**RE: FURTHER INFORMATION REQUEST UNDER SECTION 92(1) OF THE RESOURCE MANAGEMENT ACT 1991
PROPOSED OTAIHANGA ESTATES SUBDIVISION**

I refer to your request for further information letter dated 26 July 2021 (RM210147) relating to the proposed subdivision for the Otaihanga Estates located at 48 & 58 Tieko Street; 131, 139 & 147 Otaihanga Road, Paraparaumu.

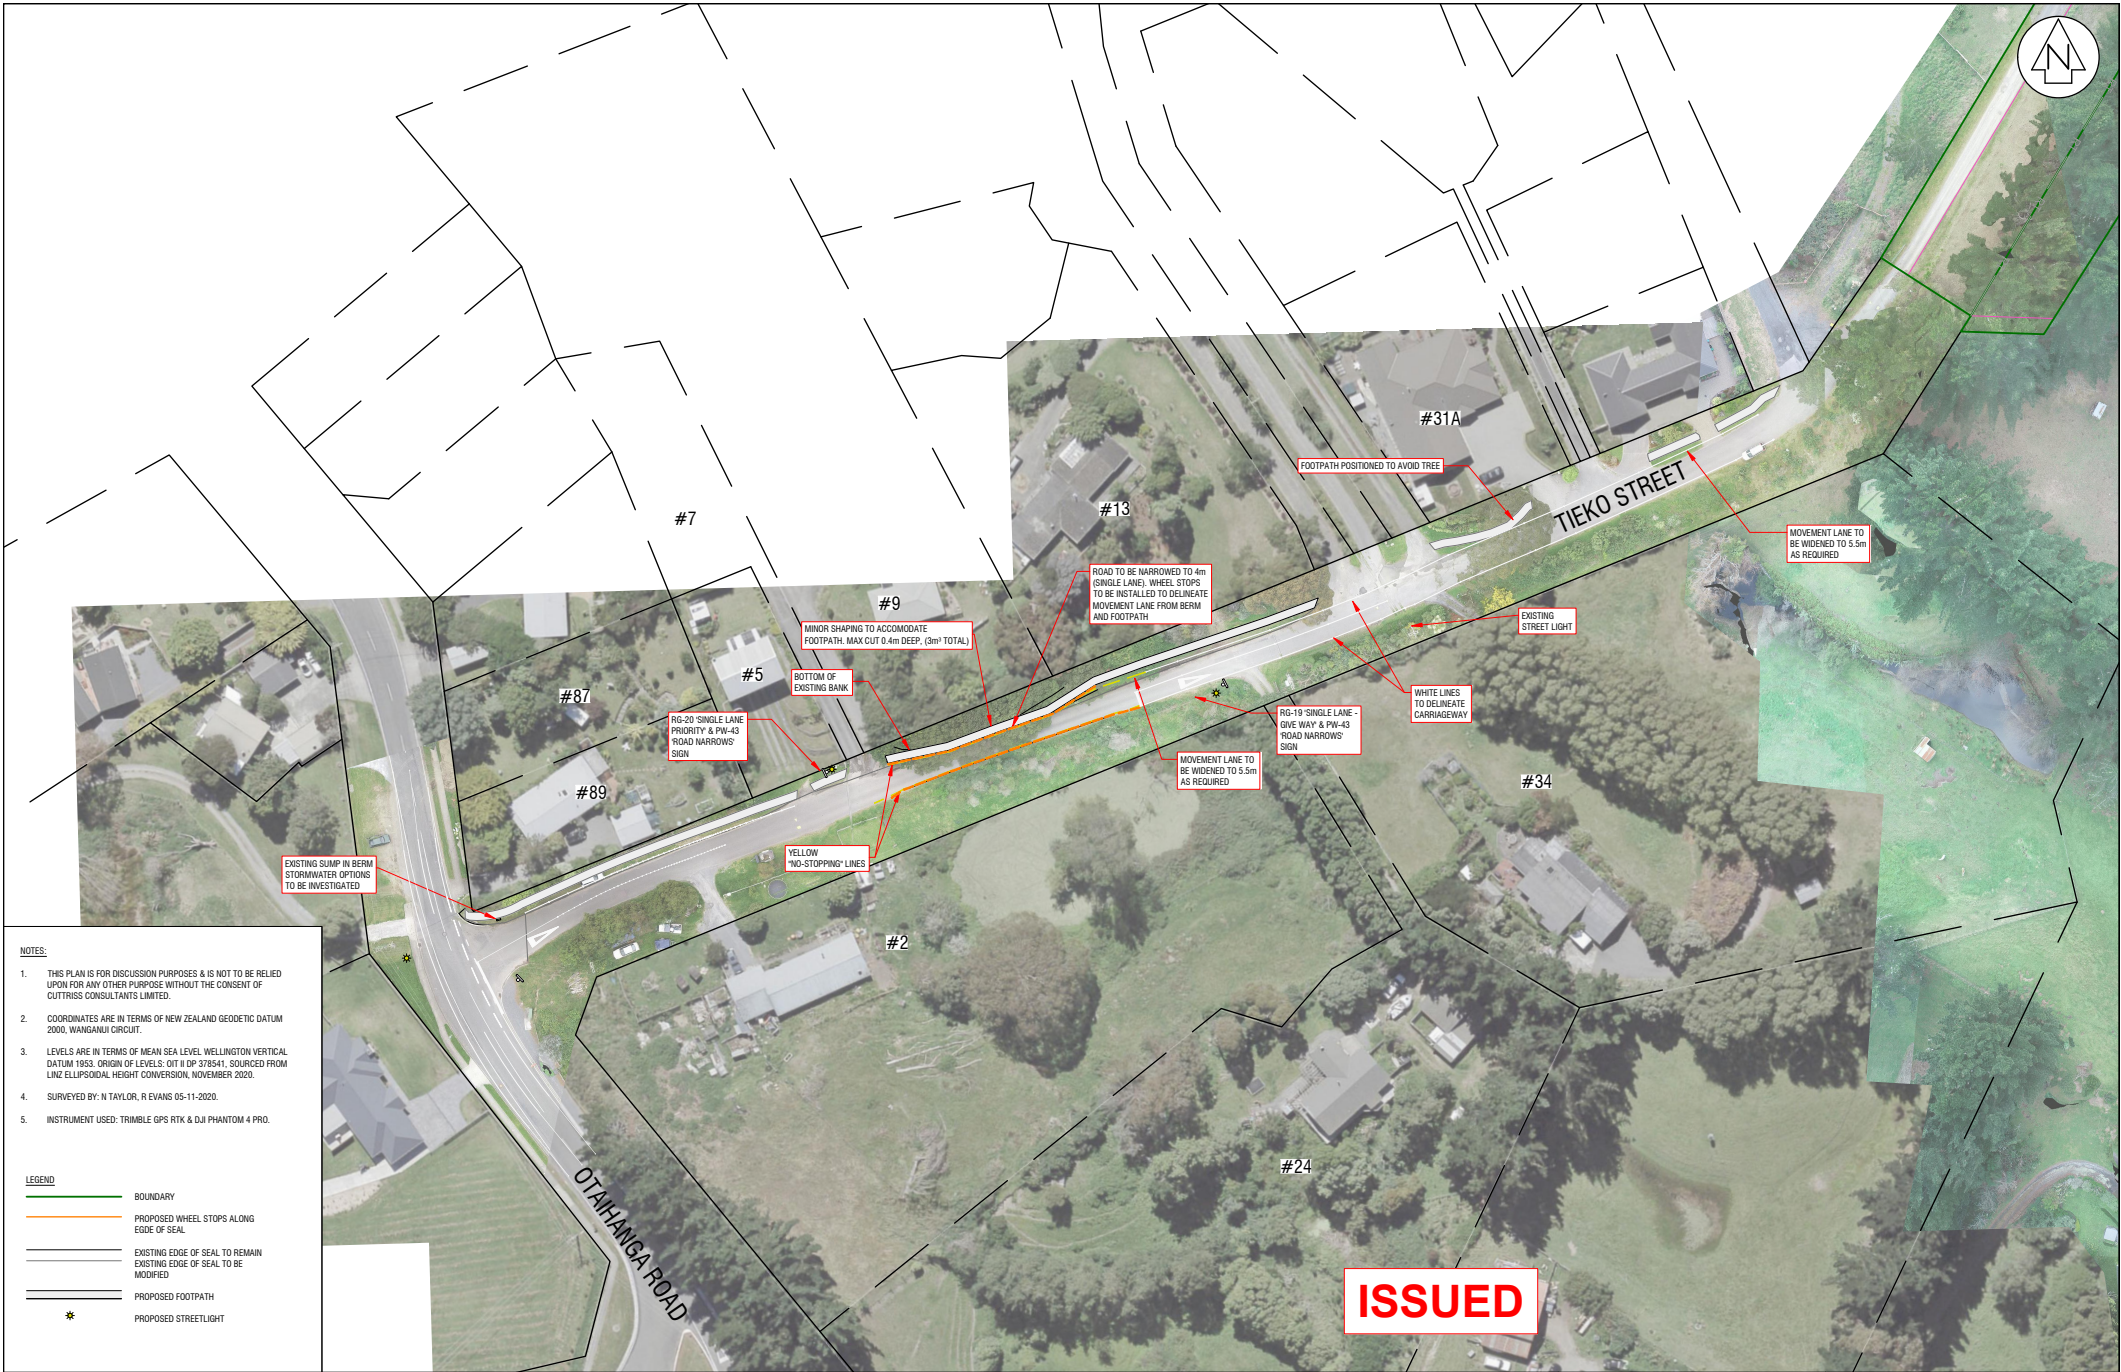
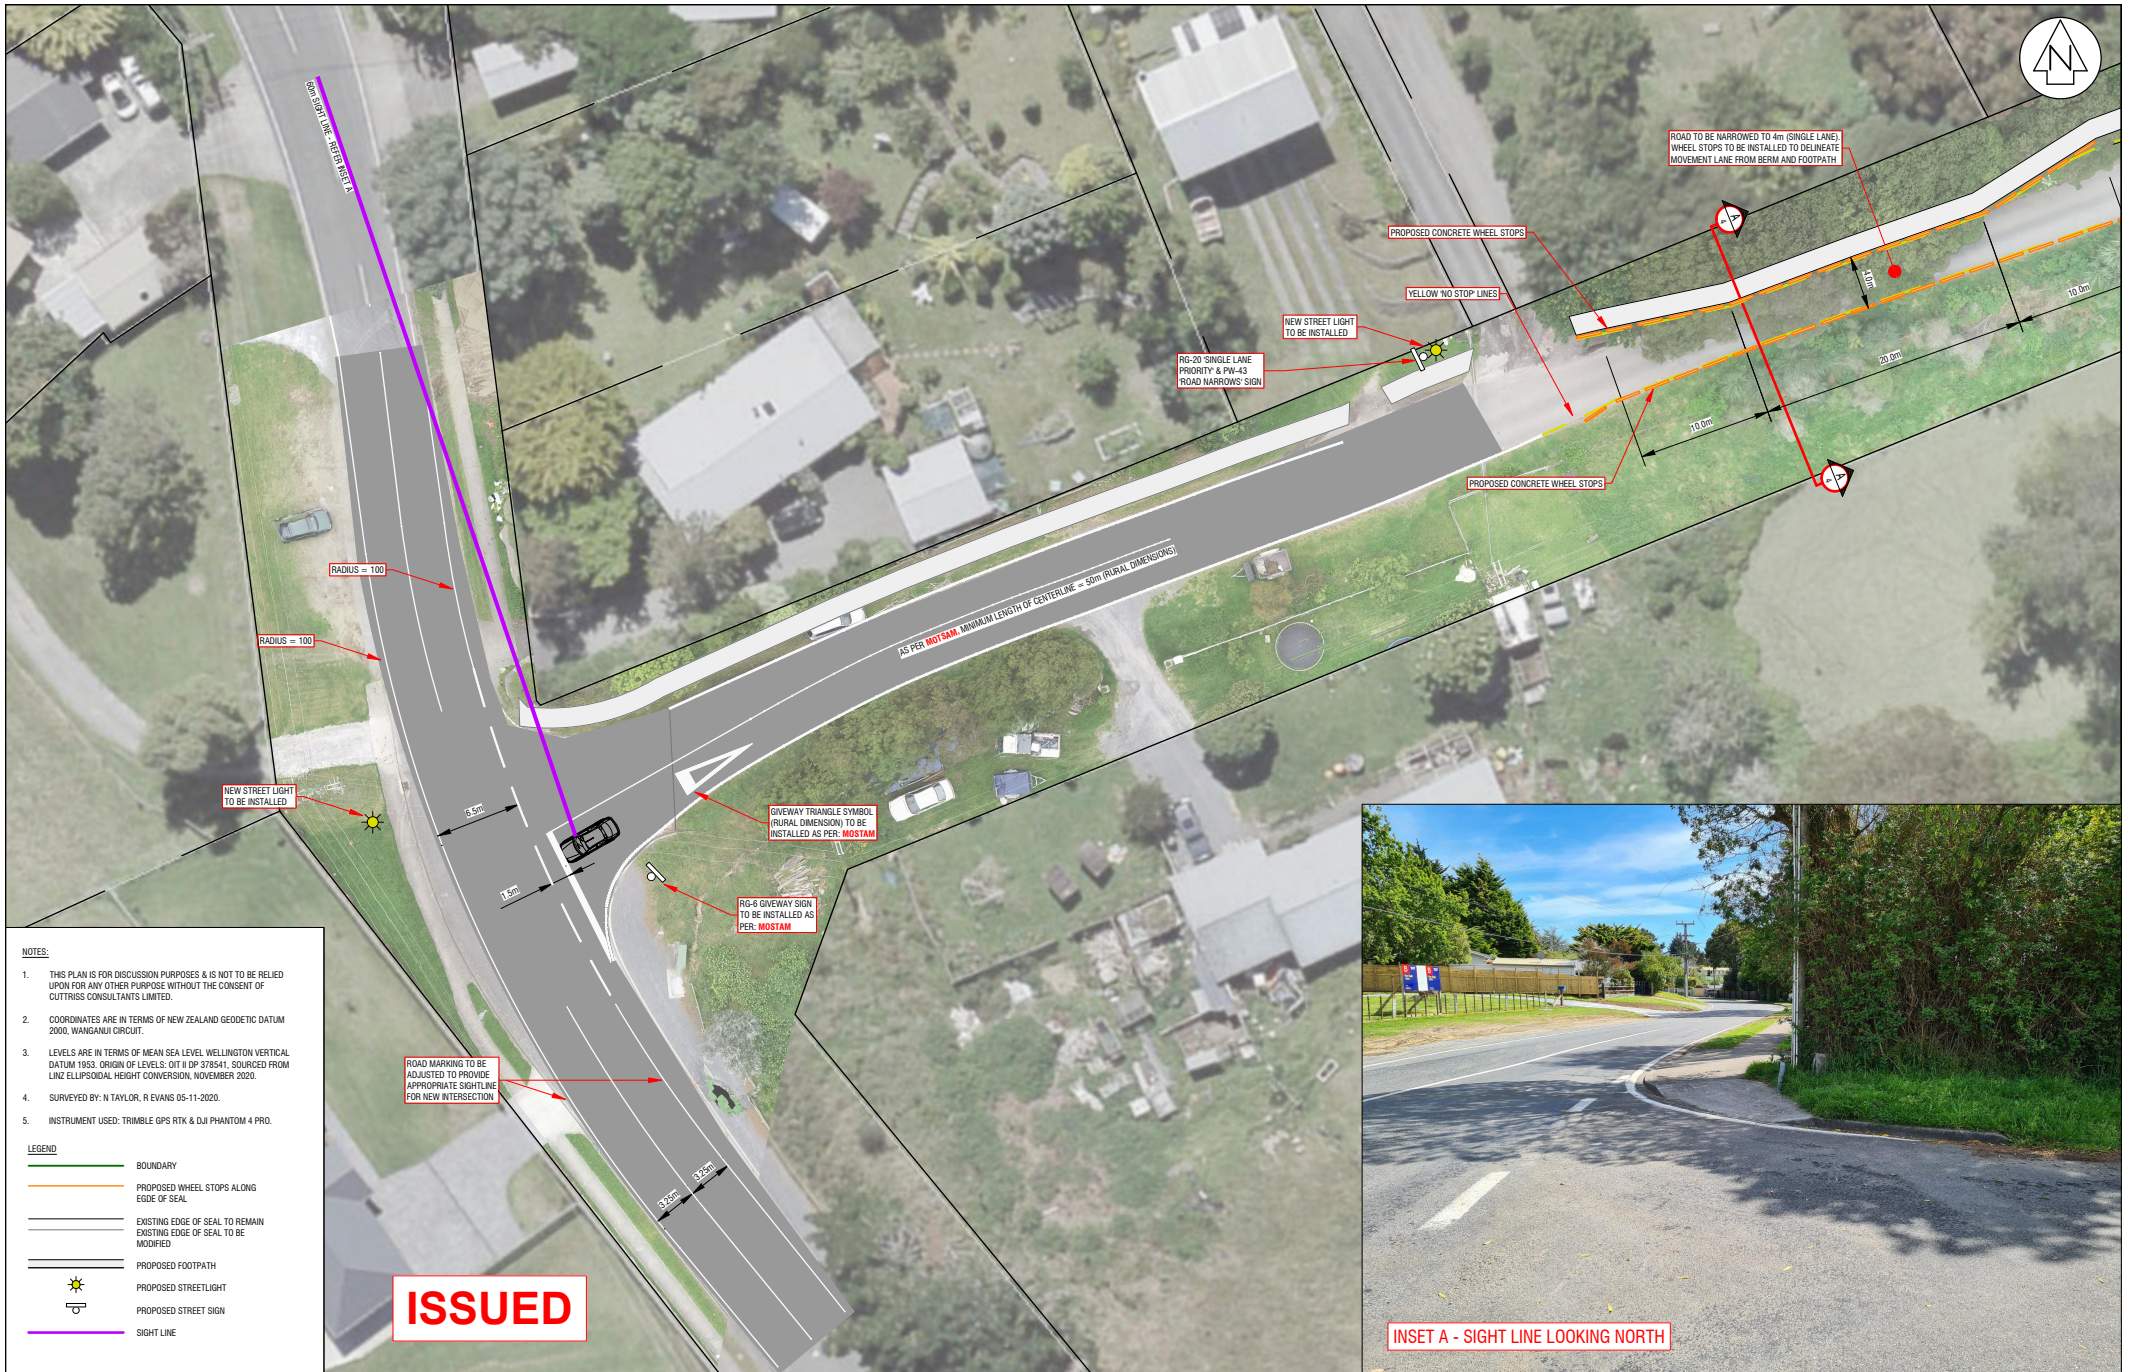
- 16 Proposed Right Turn Lane and Intersection with Otaihanga Road, Applicant to provide the following information:
- Dimensioned plan and cross section showing lane widths, shoulder widths, length of storage bay and tapers. Confirmation of compliance with Austroads and MOTSAM standards.

A plan in **Attachment 4** shows the upgrade of Tiekó Street and Otaihanga Rd that address points a, b and g above.

With regard to point b, Harriet Fraser advises that the radius of the existing bend is around 100m. With the modification to accommodate the proposed intersection the radius for the eastbound traffic flow will be 75m.

Based on Table 3.4 in Austroads Guide to Road Design Part 3: Geometric Design, a single curve section with a radius of 100m can be expected to have a section operating speed of 64km/h, this reduces to 57km/h with a 75m radius. Harriet Fraser considers that the 60km/h speed limit remains appropriate and that vehicles will continue to be able to safely negotiate this section of the road and that if needed, curve advisory signs could easily be added onto the outside of the bend.

OTAIHANGA RD SIGHT LINES

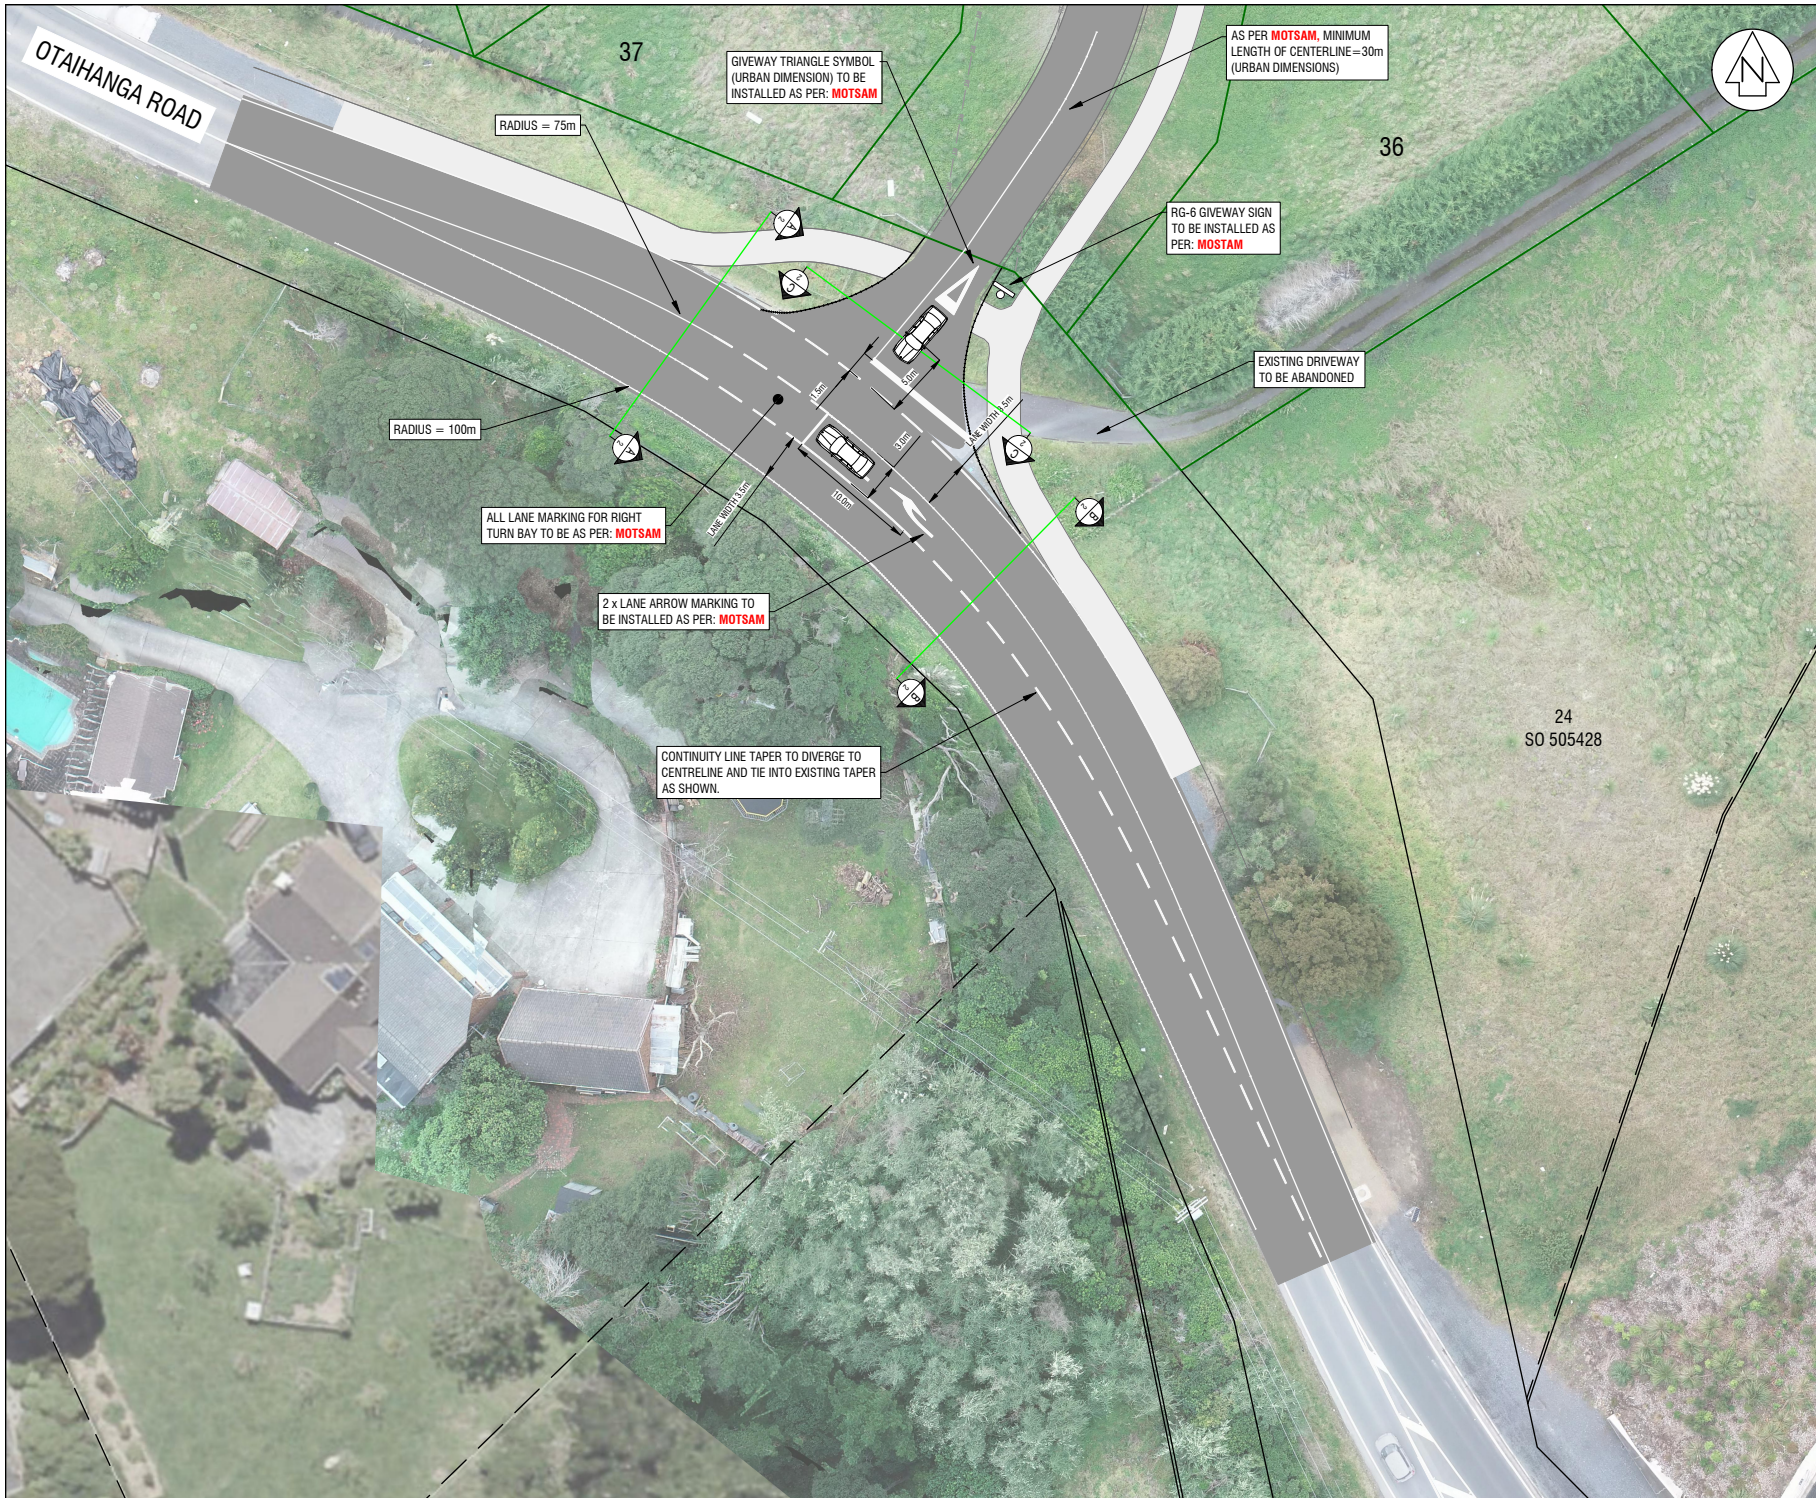
- 6 *Applicant to provide a scale drawing with dimensions indicating how the sightlines could be improved at the intersection of Tieko Street/Otaihanga Road - show both options put forward - vegetation trimming and road marking alterations.*

Please refer to the drawing in **Attachment 4** that provides the information requested.

SCALE A1 - AS SHOWN		REDUCED SCALE A3 - AS SHOWN	
FIELDWORK	NHT	DATE	07/19
DESIGNED	NHT	DATE	11/20
DRAWN	JLG	DATE	08/21
CHECKED	NHT	DATE	08/21
DRAWING NUMBER 22208 SK5			SHEET 3 OF 3 SHEETS
REVISION			A

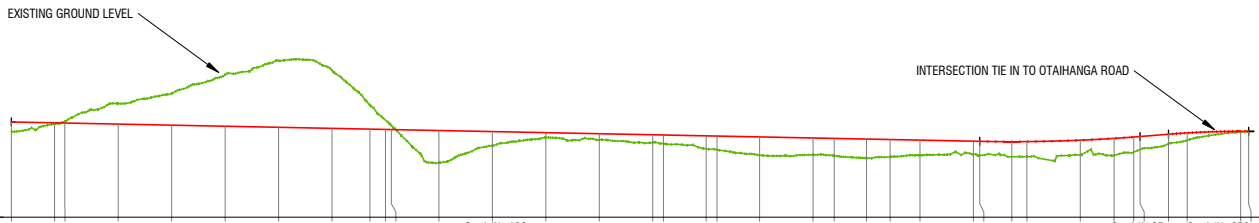
- 7 *Provide details of the vertical alignment for on the proposed roadside approach to the proposed intersection with Otaihanga Road. We want to understand crossfall for pedestrians/cyclists crossing the road and also how the level of the side road affects sightlines (object height view.)*

Please find in **Attachment 5** a drawing that provides details of the vertical alignment of the proposed intersection with Otaihanga Road.
